REQUEST FOR INFORMATION **DATE:** January 19, 2017 **NO.:** RFI-419

Project Name: 15051-Webster University Interdisciplinary Science Building Project No.: 15051

Subject: Additional handrail coordination

LECTURE HALL RAMP RAILS

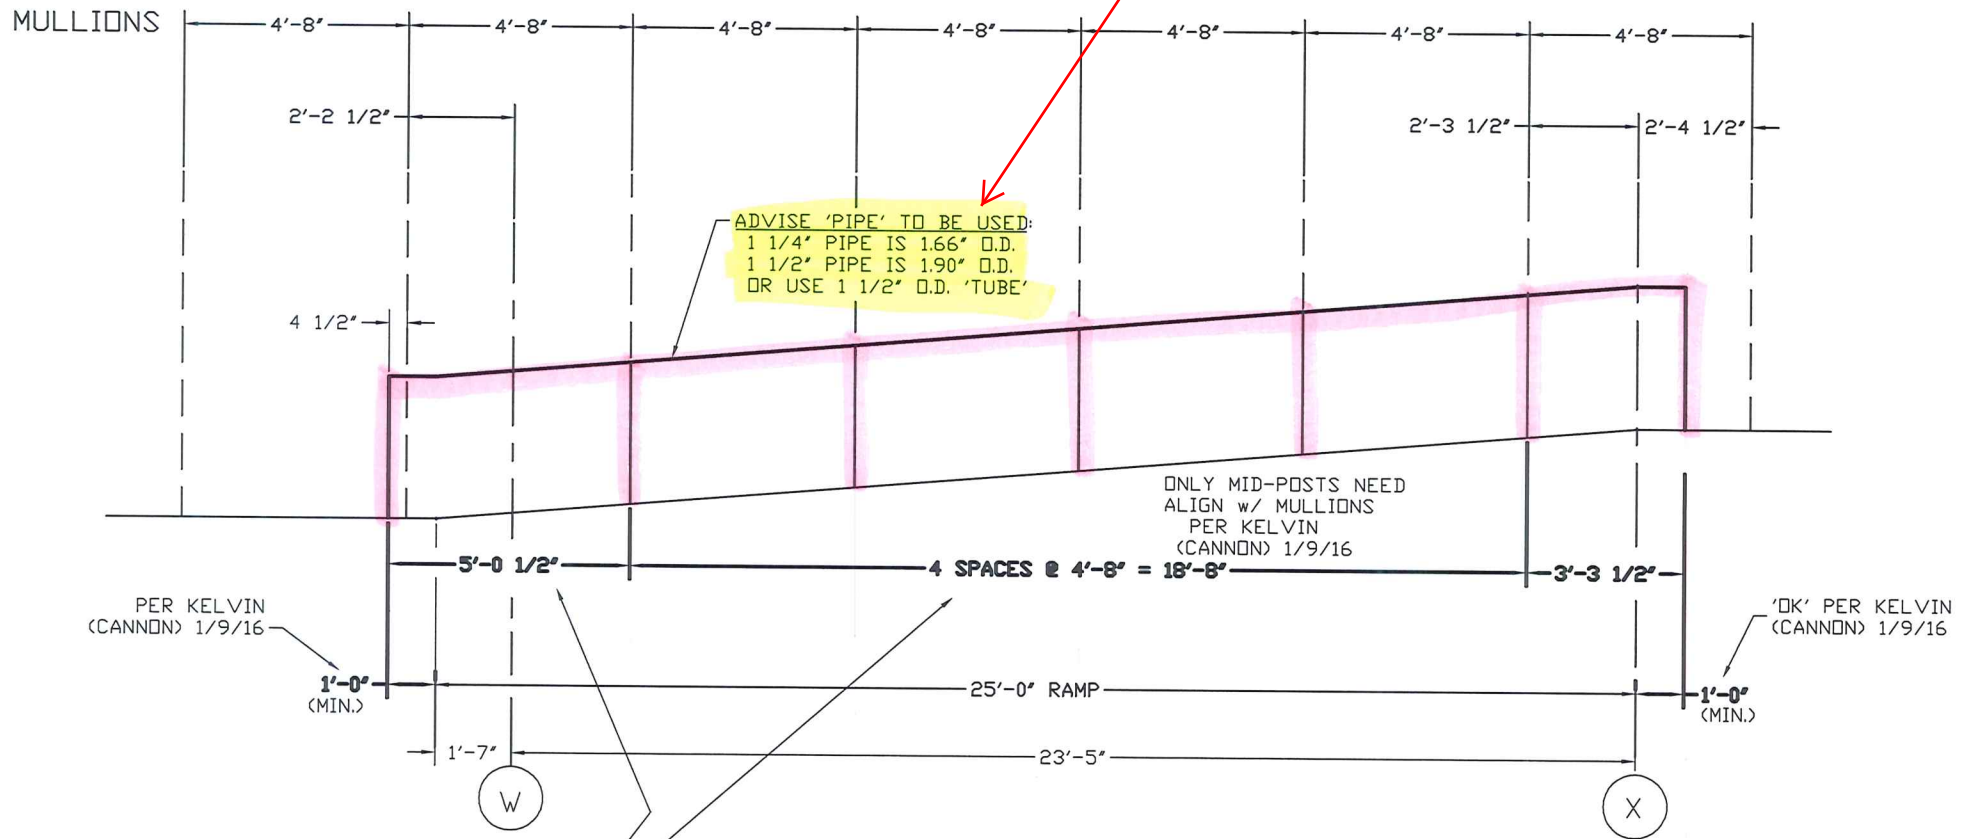
Based on the discussions during the meeting at Cannon's office; attached please find our current understanding of what the Lecture Hall Rails should look like (in elevation). However, Atlas cannot comply with both the requirement of the posts to be 4'-0" on center max (RFI 280), and that the posts align with the mullions (at 4'-8" on center) per shop drawing markup.

The sketch (attached) shows the 'center posts' aligned with the mullions, and the top & bottom posts 1'-0" minimum beyond the extents of the ramp – per Kelvin's comments at the meeting.

Please verify that Atlas is to proceed per the attached sketch, or note changes to be made. (DMA may have to review the loads/materials of these rails.)

Please verify the use of 1 1/4" pipe (1.66" O.D.) for all of the pipe/tube handrails on this project. **YES**

c. There is not an 1 1/2" O.D. 'pipe' produced (RFI 280), this would require the use of O.D. 'tube'.

d. Please verify that the response applies to the entire project, not just these Lecture Hall rails **YES**

ACCEPTABLE PROVIDED RAILINGS MEET THE PERFORMANCE REQUIREMENTS PER SPECIFICATIONS.

RAILINGS MUST MEET THE PERFORMANCE REQUIREMENTS PER SPECIFICATIONS.
